The Mississippi RiverWatchers
Response to Enerdu / OEL-Hydrosys
OE8982-00

Environmental Report on the Enerdu
GS Expansion and Redevelopment
Project

Revision 1.1

January 18, 2013

From Annex I - Page 6:

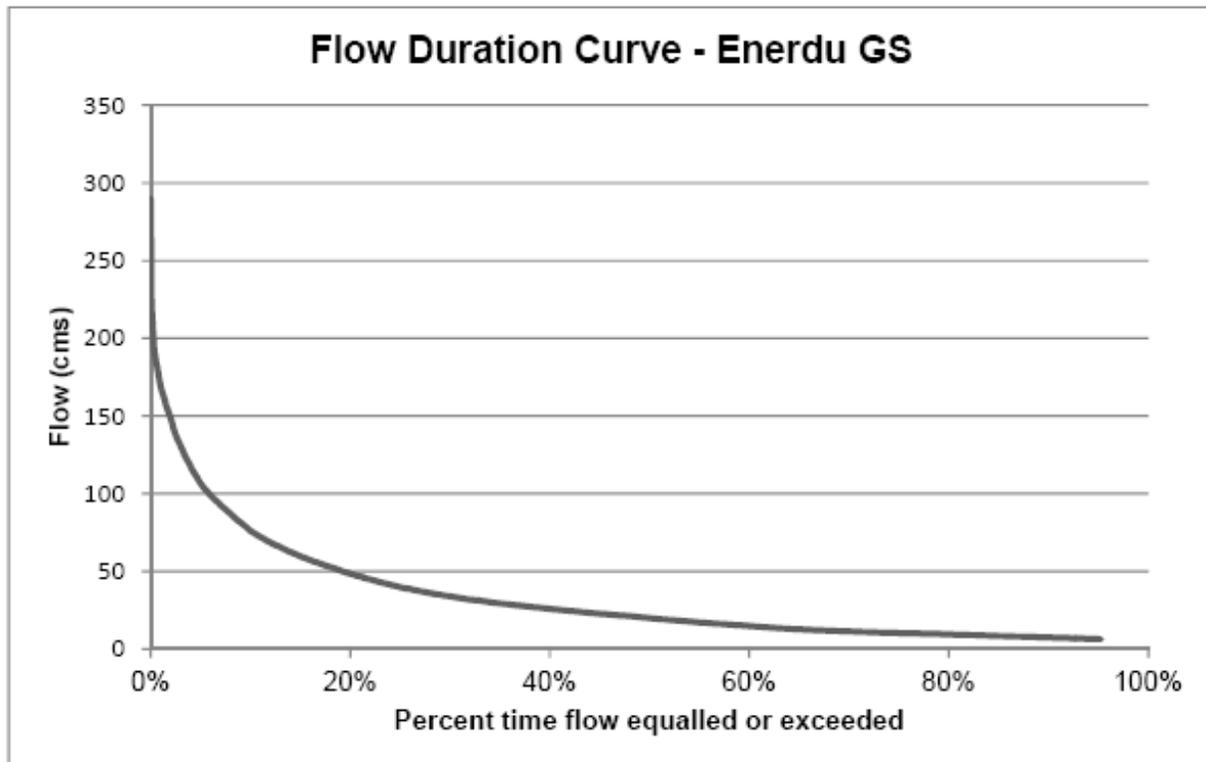
The facility upgrade has a design capacity of 950 kW and at full output will require a flow of 37 m³/s through the generators. Adding an additional 5 m³/s for weir compensation flow and flow over the Thoburn weir would bring the total required river flow to 42 m³/s.

The Flow Duration Curve shows that a flow of 42 m³/s is available less than 25% of the time. It seems uneconomic to design a facility of this capacity that will operate at full capacity for less than 25% of the time.

There is the probability of an amendment to the MRWMP that may reduce further the available head at this location and consequent reduction of power output. To make the project financially viable it is anticipated that Enerdu may be planning to operate in peaking storage mode at times of peak power rates, in spite of repeated Enerdu claims to be a run-of-the-river operation.

It may also be possible that Enerdu is planning a future request to raise the operational water level limits in the MRWMP to increase power generation.
